## Fixation of air filter mat

### PrimeServ Customer Information

No. 359 / July 2016

MAN Diesel & Turbo Turbochargers  
All NR12/S and TCR12 types  
with silencer

Figure 3 Perforated plate and tightened hose clamp

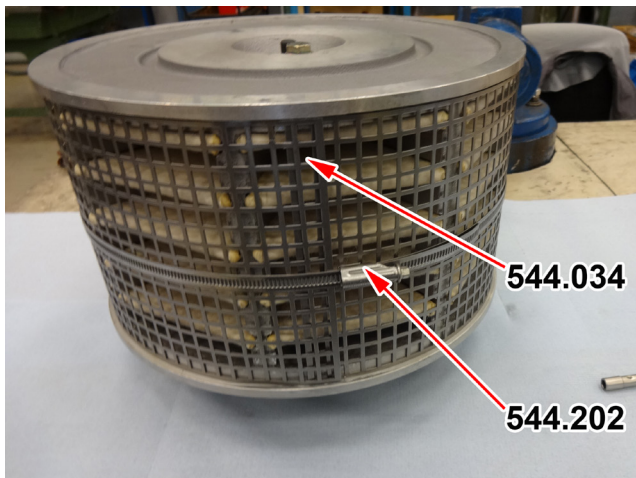
The perforated sheet 544.034 is to be fixed by a third hose clamp 544.202, when installing the air filter mat.

3. Open the hose clamps (544.202), remove the cover sheet (544.205) and the air filter mat (544.201)
4. Place a third hose clamp (544.202) in the middle over a perforated plate and tighten the hose clamp carefully (see figure 3)
